CMD 26-H7.45

**Written Submission from
Prolet Inc.**

Application to refurbish Pickering Nuclear
Generating Station and to renew licences
for the Pickering Nuclear Generating
Station and Waste Management Facility

**Submission to the CNSC Public Hearing on Ontario Power
Generation's Application to extend the Reactor Operating License
for Pickering Units 5,6,7 and 8 for 10 years by their shutdown first of all units
for refurbishment immediately after expiry of their current license on 31
December 2026**

Figure 1: PHTS over pressurization after the relief valves cannot cope with steam load

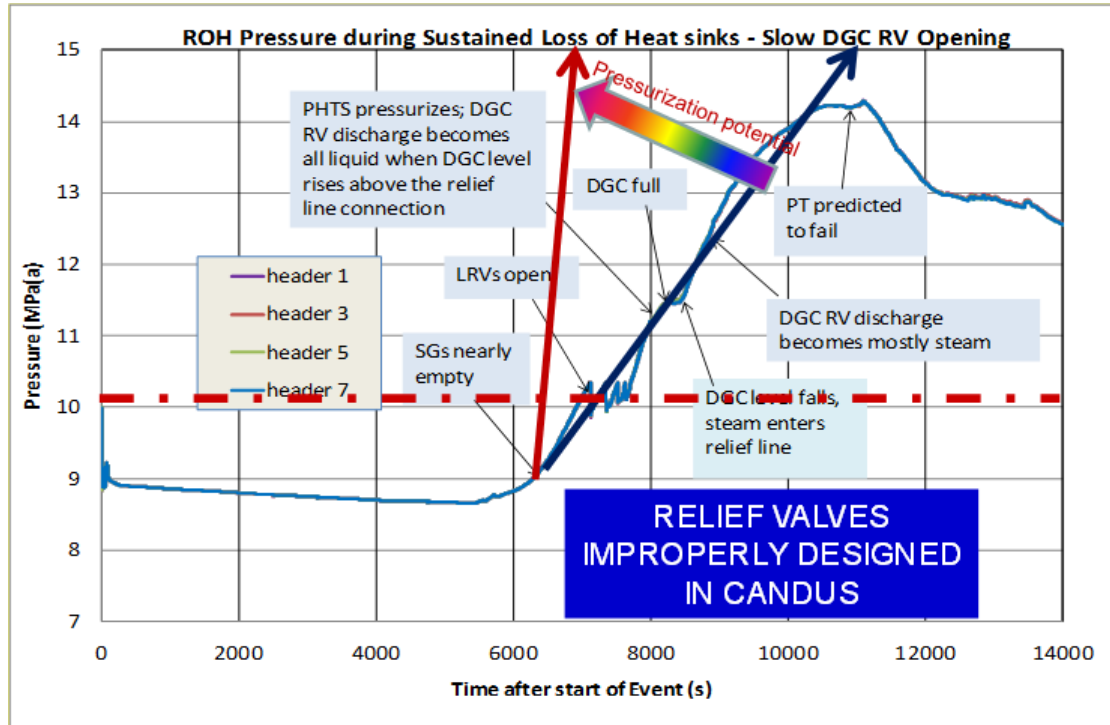
Pickering safety report clearly talks about this inadequacy but the learned CNSC staff totally overlooked the simulation results of the following figure.

4. *A high pressure steam driven turbine (installed in PLGS) can help avoid boiler dryout without operator action.*
5. *At this time the first unintentional error in CANDU design becomes critical. The system re pressurizes and attempts at this time to avoid an over pressure by rejecting the decay heat*

through safety relief valves but an inadequate steam relief capacity leads to a continued over pressurization¹.

6. So, a boiler dryout leads to an unusual for a nuclear power reactor, over-pressurization of the Heat Transport System and an unavoidable, uncontrolled failure of a pressure boundary component. The failure is most likely to be in ever so vulnerable boiler tubes, resulting in a potential containment bypass and early population exposure to fission and activation products. Analyses at AECL and a recent COG report point to a potential failure of a fuel channel instead of a bunch of boiler tubes. There is ample data to dispute that outcome. In any case, in a properly designed reactor, nothing should fail upon an over-pressure transient.

Figure 2: Channel heatup as a function of onset of heatup. note fuel bundle geometry after significant heatup.

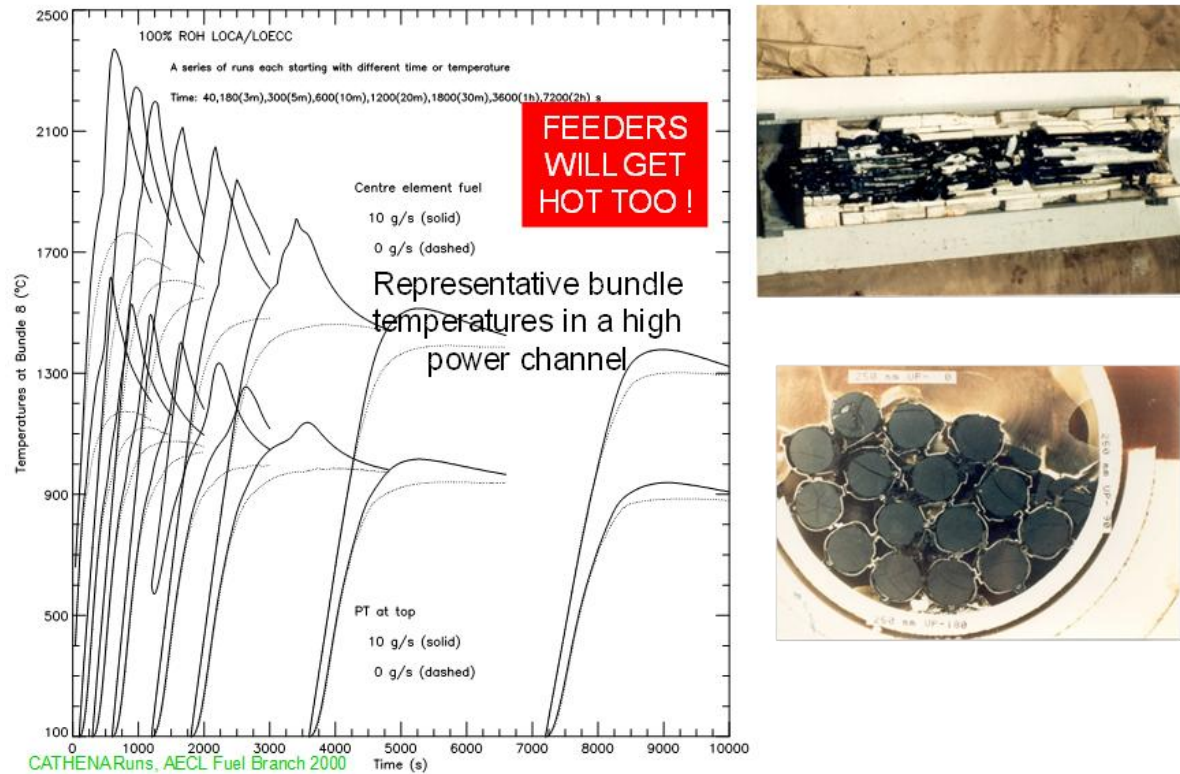
17. *Channel segments begin to disassemble and supported by underlying channels and constrained by in-core devices continue to cascade down and heatup during holdup periods.*

Figure 3; Water holdup in end fittings and piping as source of fuel and feeder oxidation. Moderator water also a source after channel perforation.

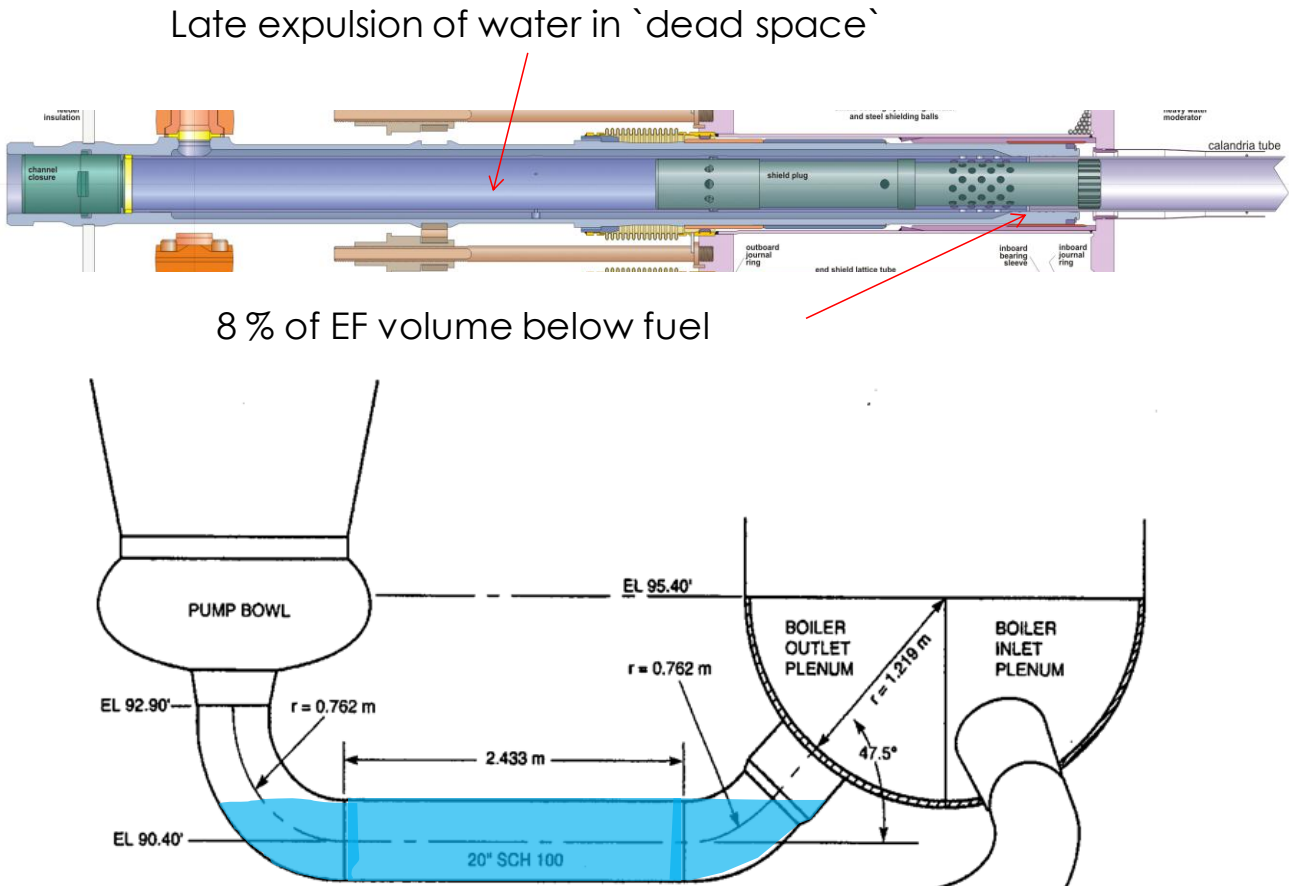
18. Internal sources of water remaining in the end fittings, pump inlets, fuelling machines also contribute to oxidation of fuel and feeders. In addition water, steam ingress from the moderator into disassembling channels will contribute to steam availability.

19. As the fuel in the channels begin to heatup so do the end fittings and feeders. Oxidation of feeders starts at about 550°C while fuel oxidation starts at about 800°C. Over 7 km of carbon steel feeders provide over 1800 m² of carbon steel surface area for oxidation. Carbon steel oxidation to FeO /Fe₃O₄/Fe₂O₃ (in 95/4/1 ratio of Wusite, Magnetite and Haematite) is faster than that for Zircaloy at the same temperatures and the iron oxides have a propensity to peel off and expose fresh steel carbon surface for accelerated oxidation. Stainless steel end fittings also join in the oxidation process, albeit at a rate that is at times 10 times slower. Part of end fittings also include a heat sink to the end shields. Heatup of feeders will likely start fires in the feeder cabinets.

Figure 4: Oxidation rates of different channel materials

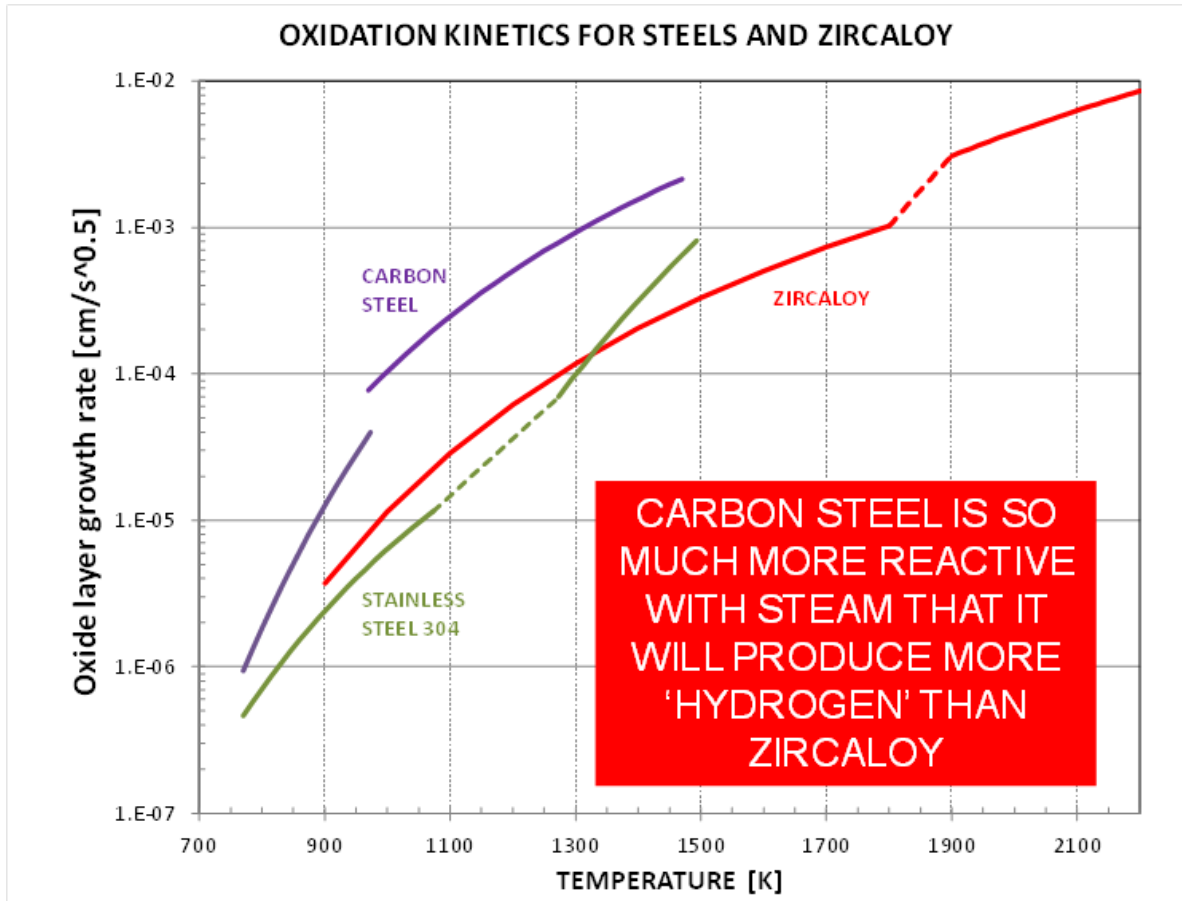
22. More deuterium (isotope of hydrogen) is produced by intact carbon steel feeders than by intact fuel bundles. This has been confirmed by analyses using a new computer code ROSHNI.

26. Analyses confirm that the whole CANDU core cannot just collapse down after a certain amount of debris have formed. The erstwhile MAAP-CANDU assumption of a 'core collapse' is a convenient way of decreasing source term to please ourselves. It is the channels that do not fail that contribute most to hydrogen source terms, ROSHNI analyses now reveal. A large number of fuel bundles (~33%) may remain in stubs at the end of channels that do not experience rolled joint pullout. Oxidizing feeders in channels that disassemble will cool down relative to feeders in channels that remain intact.

**Figure 5 : CANDU fuel tray towers - structure and typical placement within the pool.
Pictures not from Pickering.**

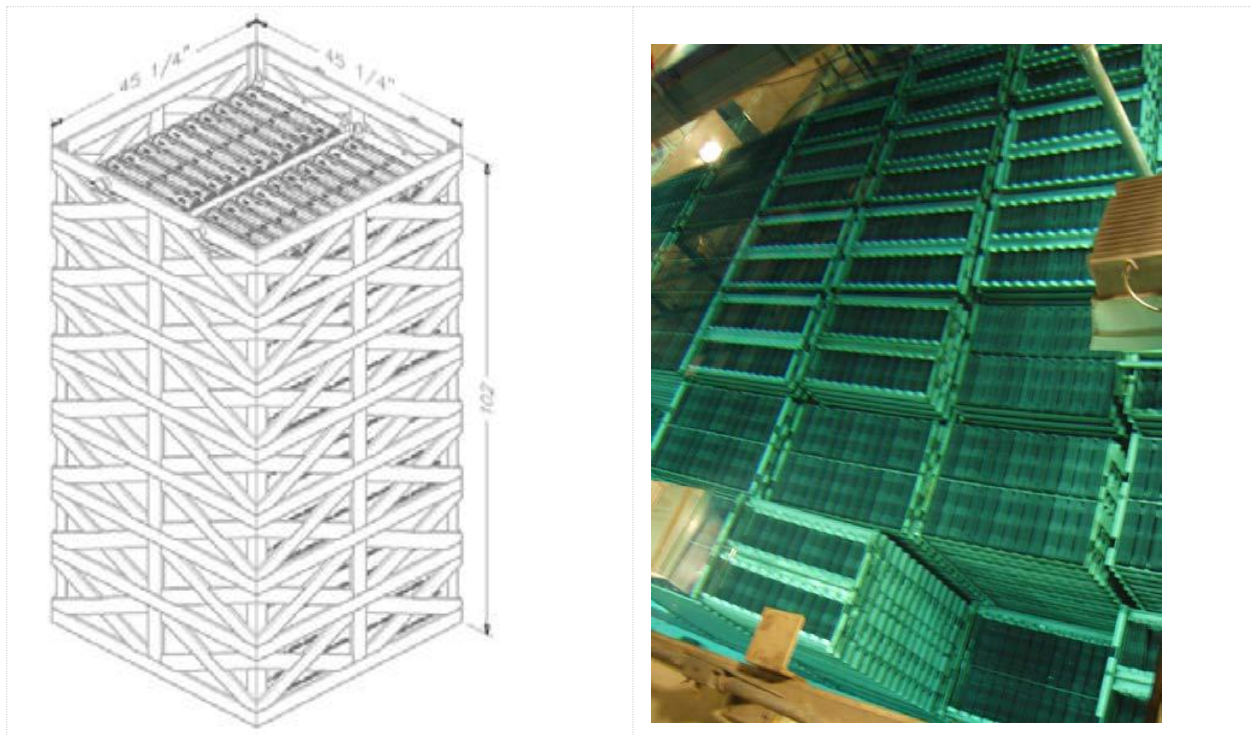
The CANDU fuel bundles are rather densely stored in stacked a ‘fish-basket’ like relatively tightly packed, congested configurations that may severely limit the potential heat removal by air natural circulation after a loss of liquid water envelope. A potential exists for significant off site doses, should an accidental and sustained uncover in air of spent fuel bundles cause energetic reactions leading to sheath failures and releases of radioactive fission products.

For PHWRs, related evaluations have largely been qualitative and dismissive, citing the substantially lower than that for LWR decay heat owing to their substantially lower burnup. However, freshly discharged fuel bundles are added almost daily to the pool. Similar to LWRs, their dense horizontal stacking in tightly packed vertically piled trays creates a potential for adverse consequences following an accidental, sustained fuel uncover in air. This also makes the
